MARKED UP PRINT

This drawing is the property of & Copyright of VIVAWAY LTD. 36-38 JOHN ST., LUTON, BEDS., ENGLAND. LU1 2JE Phone 0582 423425	Change Date	Sheet 2 of 2	ISS. 1.
	TITLE	BBC 6808 UPGENE

Change Date Sheet 1 of 2  
TITLE BBC 6808 UPGRADE  
DRG. No.

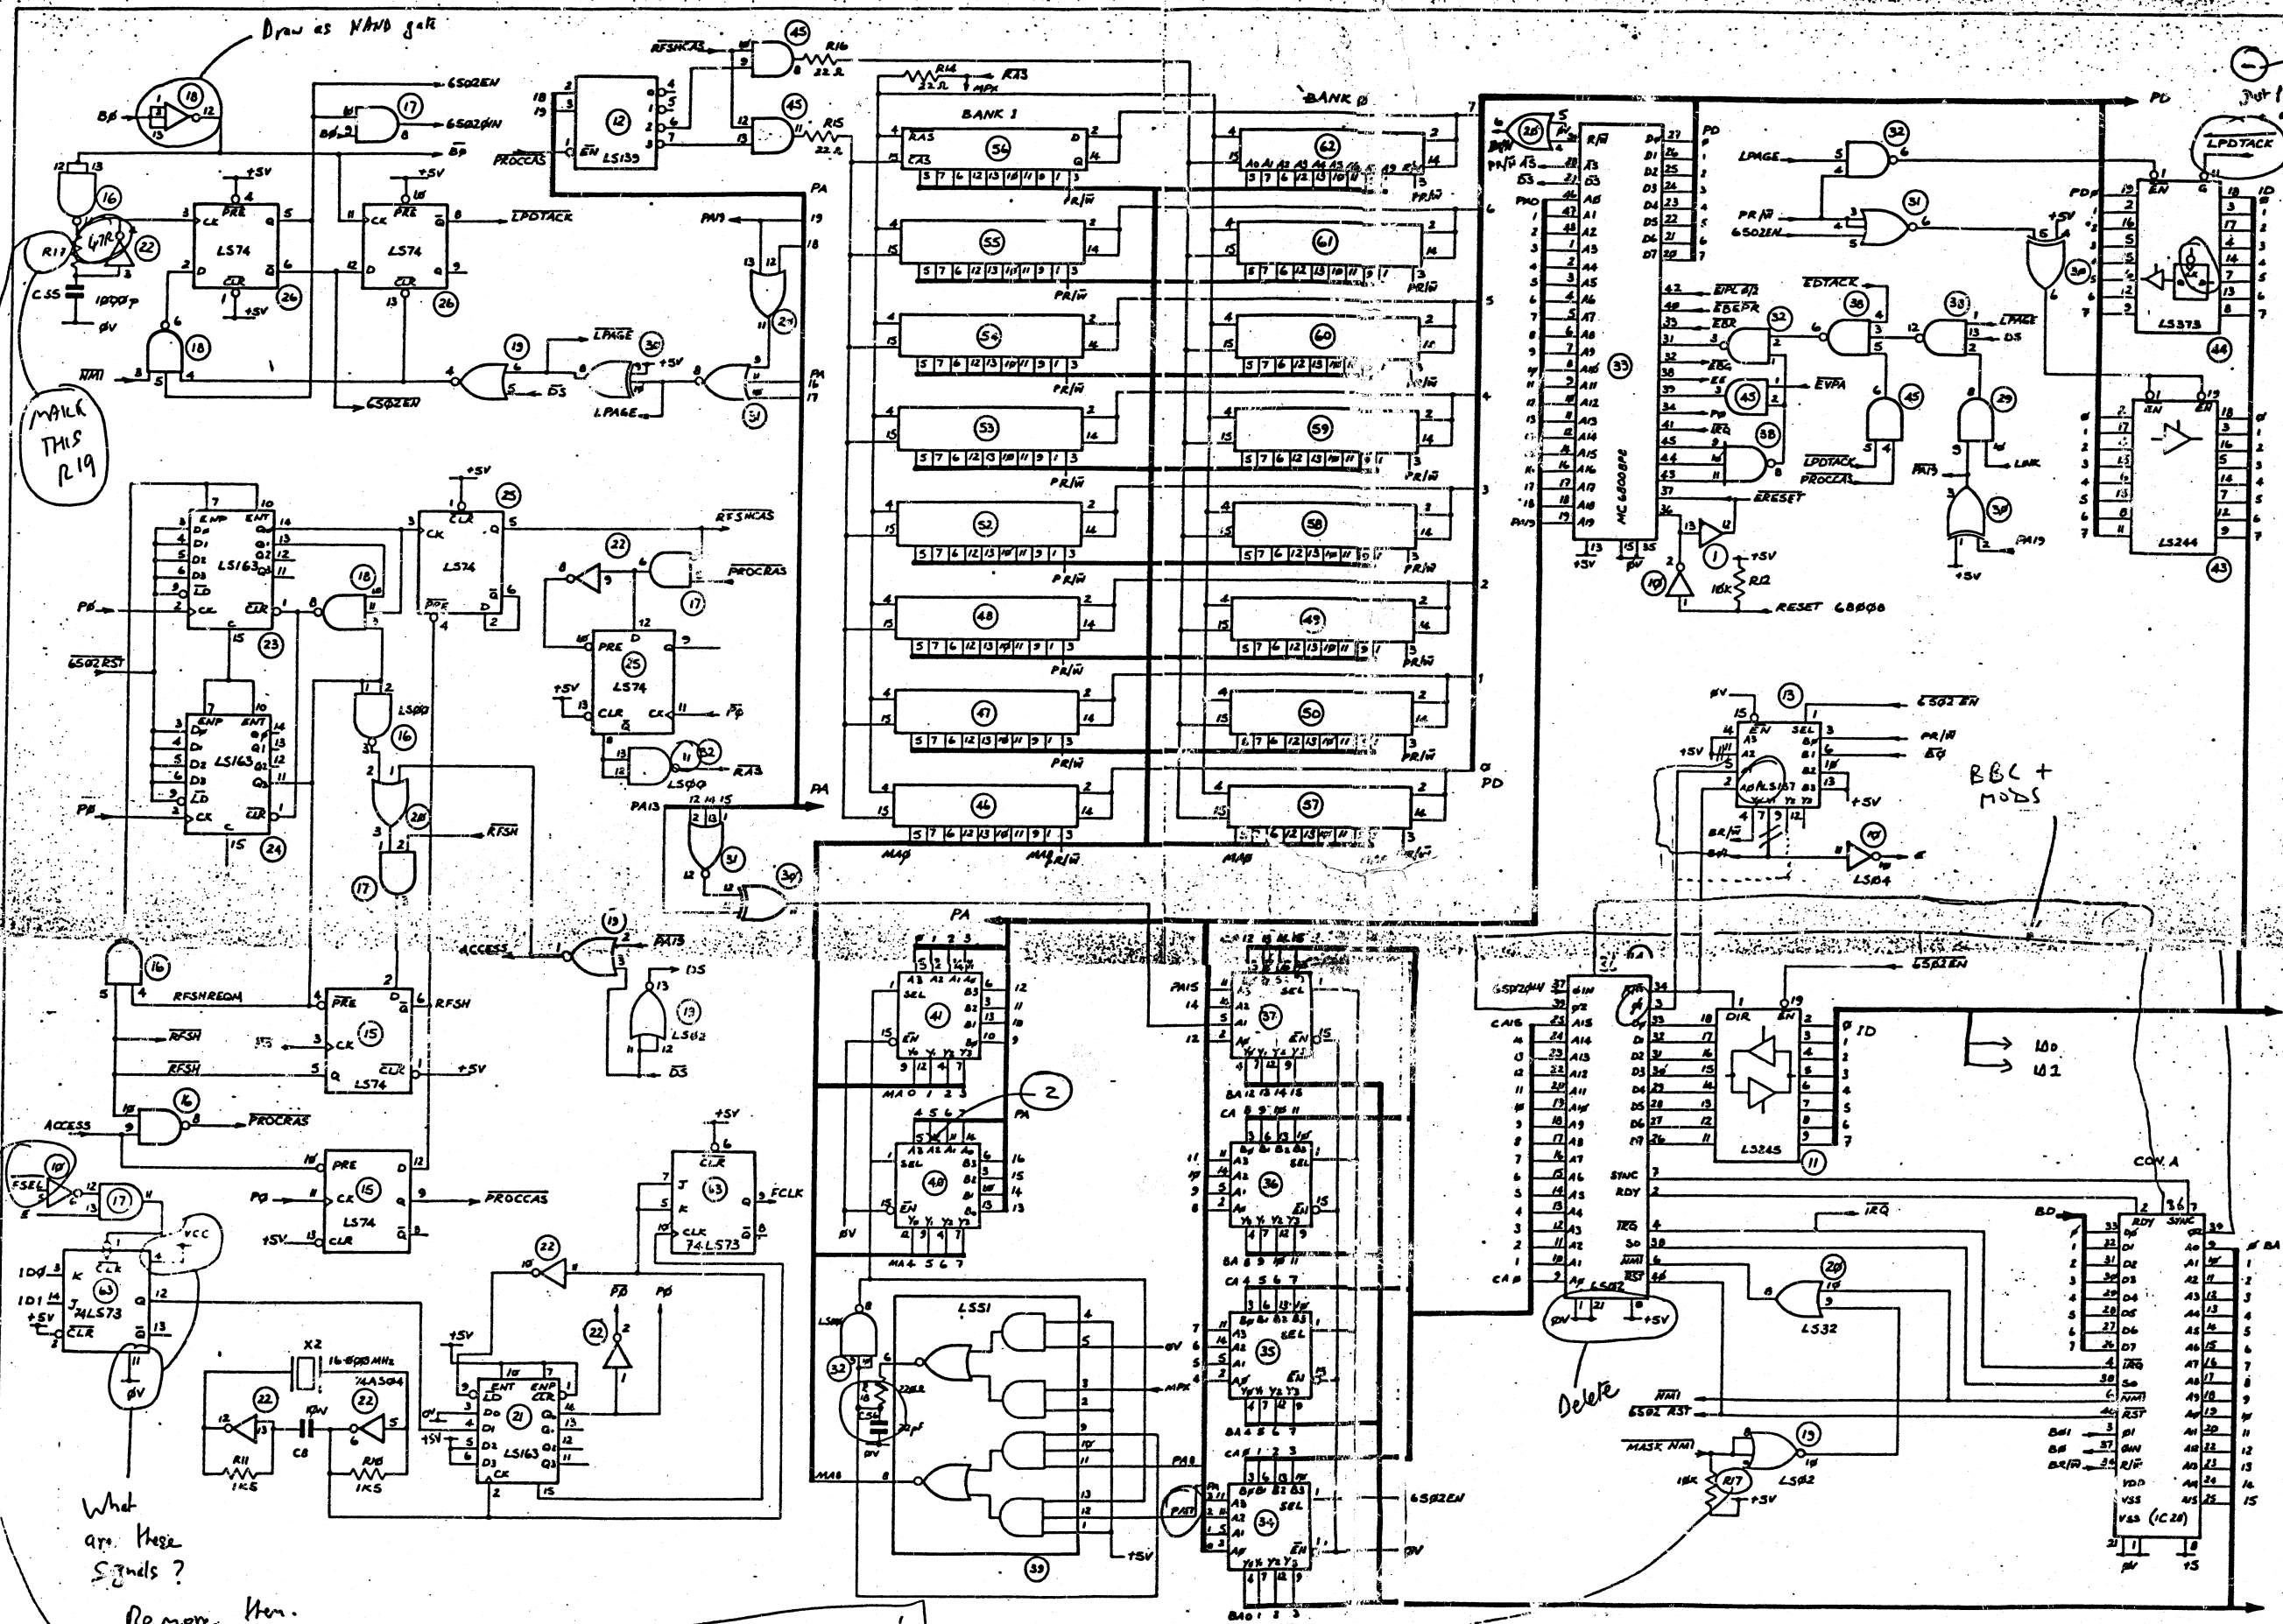
Could all be moved right and RP resistors drawn in.

Values of resistors in RPS?  
 You have a lot of room here... why empty everything up?  
 No R pin numbers

Where are all the unused gates?

No RP pin numbers.

MARK THIS R19

Draw as NAND gate

What are these signals?  
Remove them.

There are two R17's  
ON THE CIRCUIT DIAGRAM  
AND THE SILL SCHEMATIC
